SI M51 01 13
Body Equipment

Service Action: Replace Both Sun Visors

Produced from August 2010 to April 2011

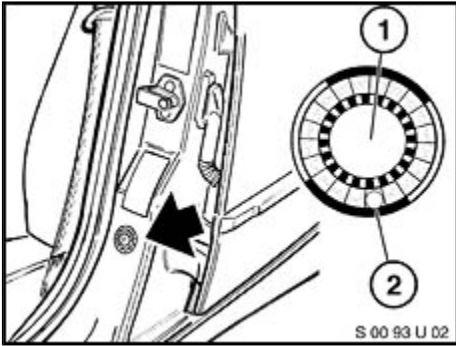
When opening the sun visor mirror cover, the pivot pins bind.

The spring tension is too great and weak pivot pins can break.

Replace both sun visors. Refer to ISTA Repair Instruction 51 16 080, "Remove and installing or replacing the left or right sunvisor and counter support."
